July 16, 2019 BOARD OF COUNTY COMMISSIONERS ORANGE COUNTY, FLORIDA Y19-768-RM / ADDENDUM NO. 3 YUCATAN PARK PLAYGROUND COVER BID OPENING DATE: July 25, 2019

A01.01

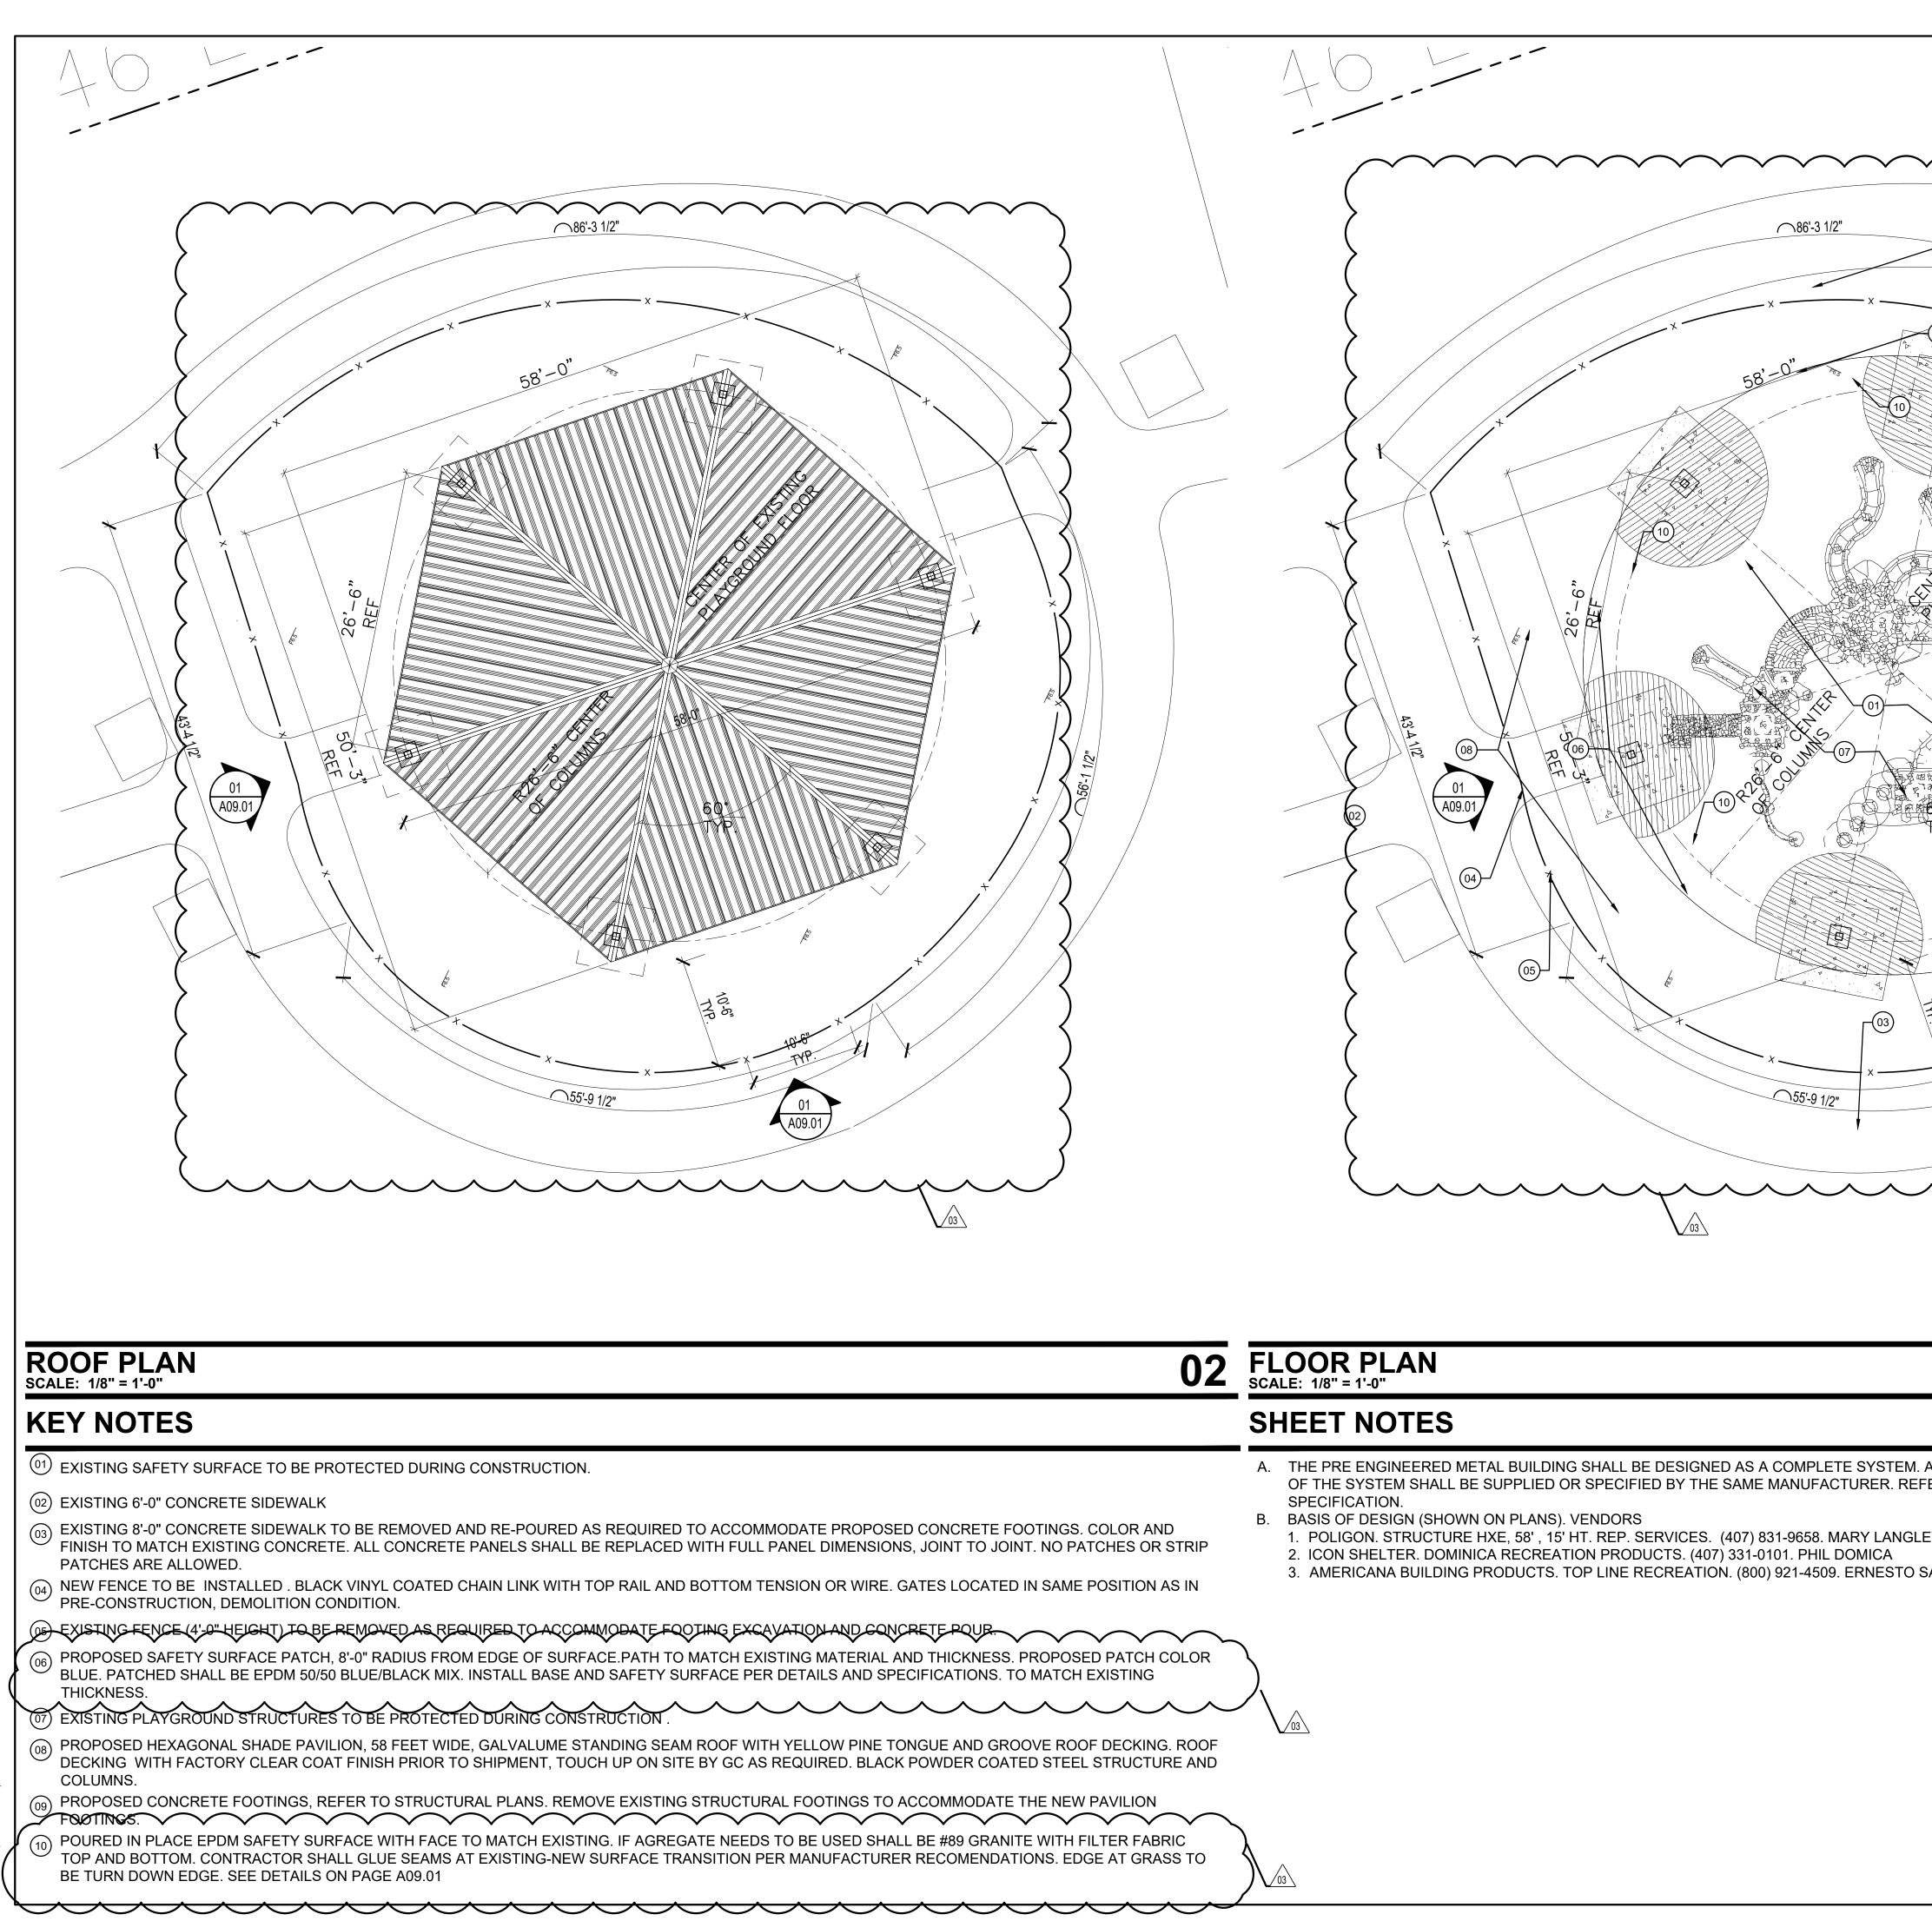
- A. The bid opening date remains July 25, 2019 at 2:00 p.m.
- B. Clarifications: please see revised drawing sheets A01.01 and A02.02
- C. Questions and Answers:

3. QUESTION: Note 4 and 5 on page A.01.01. If we remove the gates, we can reuse them. But if we remove fence we have to replace please confirm.

7. QUESTION: Are there any as built plans that could confirm the size of the current footers that we are to remove? I used a probe rod and see that the footers extend past the rubber surface much more than the cross hatch area that we are being asked to remove on the plans page A01.01 show. Basically did someone confirm that the existing footers are in fact as shown in detail 2 of page A09.01 because that's not what we discovered on the one post we probed.

ANSWER: The intent of the fencing and gates was to remove and replace. Any damage to them during the construction process would have to be repaired

ANSWER: Contractor means & methods to know the project parameters.
